# **Dubbo Quarry Continuation Project Amendment Report**

# **Amendment Report**

Holcim (Australia) Pty Limited

J210189 RP#3

Dubbo Quarry Continuation Project Addendum Submissions Report Figure 3.1

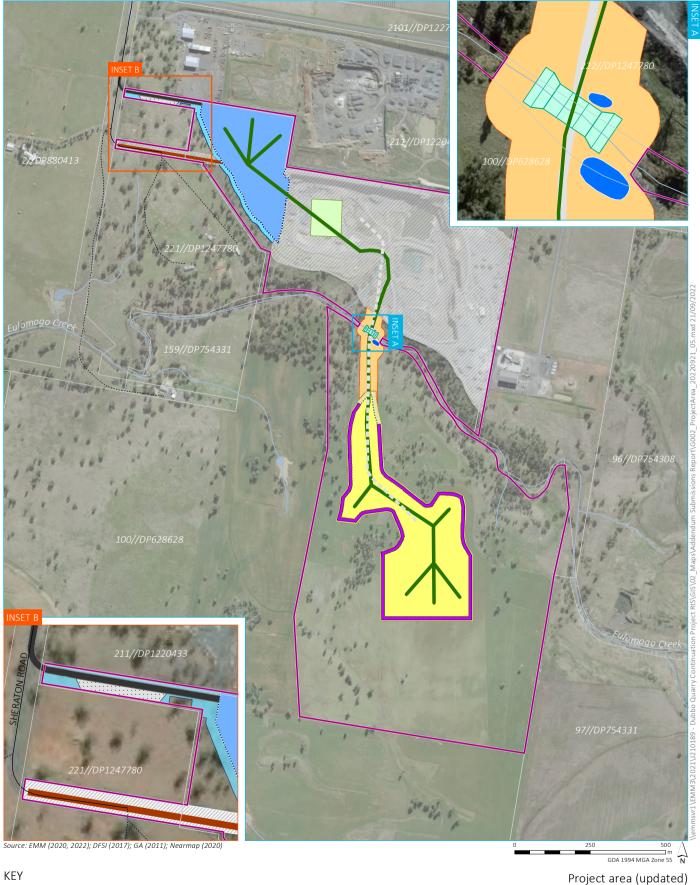
Extraction within the East Pit has required the decommissioning of the processing infrastructure which was located on the southern boundary of the quarry area and has been relocated to the floor of the West Pit (see Figure 3.1). The West Pit pond, an in-pit water storage, has also been removed to allow for the relocation of the processing infrastructure and continued extraction of the existing resource.

The West pit will continue to be the location of the processing infrastructure for the duration of the project (see Figure 3.1 for indicative location). The processing infrastructure currently includes a mobile processing plant and product stockpiles.

Figure 3.3 Typical conveyor dimensions

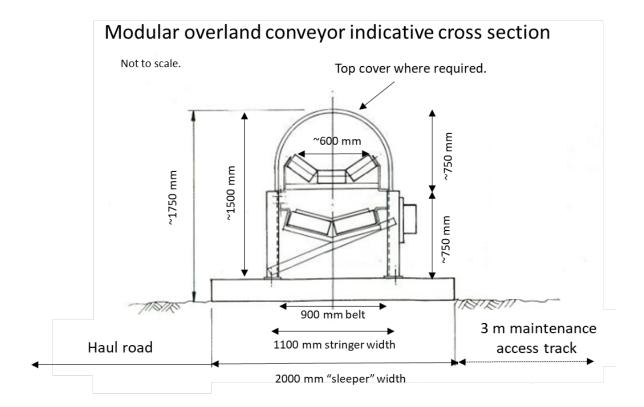
A cross-section of a typical overland conveyor is provided in Figure 3.3. The system installed at the quarry will typically be of the dimensions and general characteristics shown, other than where topography dictates to maintain a suitable gradient. Additional height is required at transfer points between conveyors and feed hoppers with an approximate maximum height of 5 m.

Figure 1 – Updated Site Map

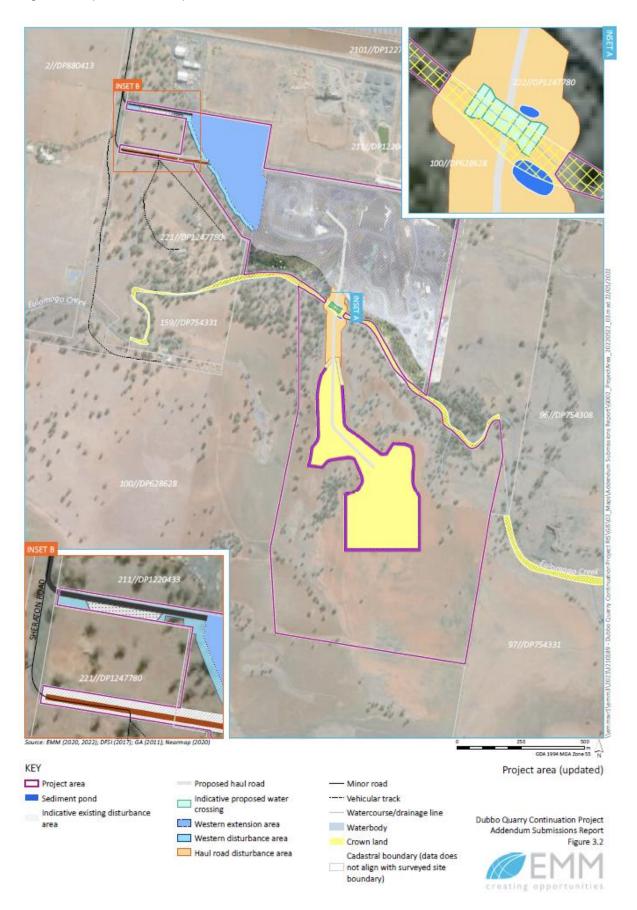
To allow efficiency in quarry operations a ramp will be constructed at the north-west point of the WEA to allow vehicles to access the site via an access route located within the quarry pit (see Figure 1). This will allow product trucks to be loaded at the stockpile area adjacent to the new processing area. Product trucks and other vehicles will be able to exit the quarry pit via an existing ramp to the south and access other stockpile areas, administration buildings and the weighbridge. Vehicles will then exit the site via the same route.

As a result of the proposed in-pit access, the proposed access road has been modified from that presented in the EIS. It will now finish at the boundary of the WEA instead of being constructed around the boundary of the pit (see Figure 1). This will allow the boundary of the WEA to extend up to the property boundary, with an appropriate setback determined by quarry safety considerations.

Figure 2 - Plant layout - located within the existing pit is approx 100m x 130m, and

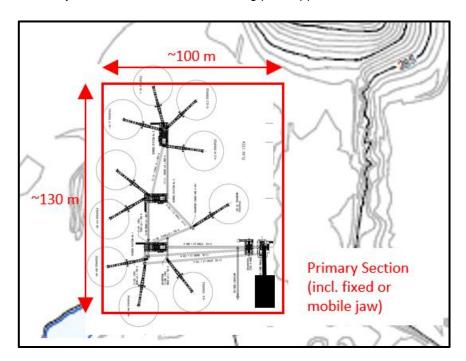
Holcim is considering replacing the mobile processing plant with a fixed processing plant at the same location. A layout diagram for a fixed processing plant is provided in Figure 2. The fixed processing plant will have the same capacity but would have a larger footprint than the mobile processing plant and, therefore, updated technical assessments have conservatively assessed that the fixed processing plant will be in place for the project duration.

Figure 3 - Typical cross section of a conveyor

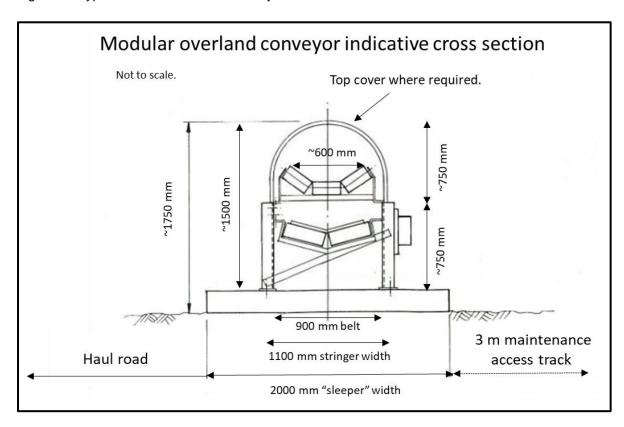
Holcim is proposing an option to use conveyor systems for the project as an alternative to truck haulage of product from the active extraction area (either the WEA or SEA), to the new processing area. The conveyors would follow the alignment of proposed haul roads and would be constructed within the proposed disturbance footprint presented in the EIS. They would be set at approximately 1-1.5 m above the quarry floor (see Figure 3), with the exception of the crossing of Eulomogo Creek, where the conveyor would be set at height of 283 m AHD to be above the 100-year flood level. In this case, road truck haulage would still be undertaken occasionally in case of conveyor shutdown or maintenance.

Figure 2.1 Indicative overland conveyor location

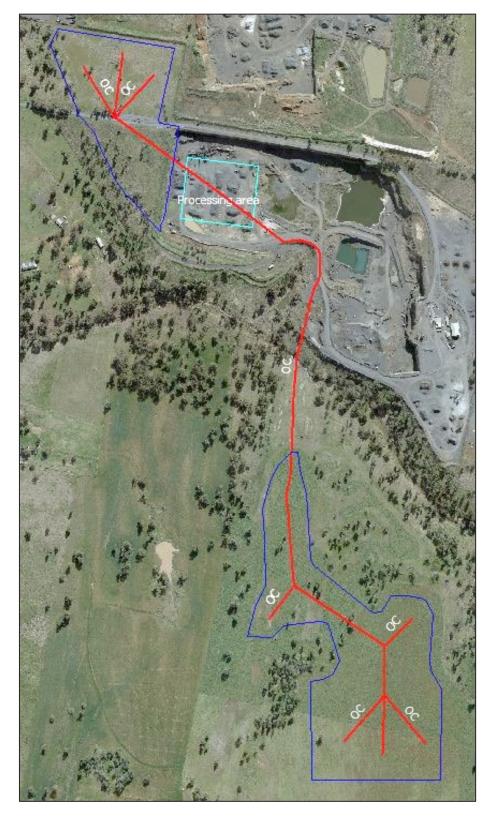
The overland conveyor is proposed to be located along the haul routes (inside haul road corridors), from the WEA or SEA to the processing area (refer to Figure 2.1).

Noise from the overland conveyor is predicted to be lower or, at most, the same to that from haul trucks at neighbouring residential receivers. Noise modelling for the project used a sound power level of 111 dB(A) (per unit) for haul trucks, whereas a sound power level of up to 84 dB(A) (per linear metre) has been assumed for the type of overland conveyor that would be installed under the project. Where noise issues have the potential to arise, for example at transfer points or where the overland conveyor runs outside the pit, noise mitigation measures (eg attenuation covers) may be implemented to minimise potential noise impacts at neighbouring residential receivers. Additional noise mitigation measures such as the use of 'quieter' systems (eg varied rollers) and regular maintenance could also be implemented where required.
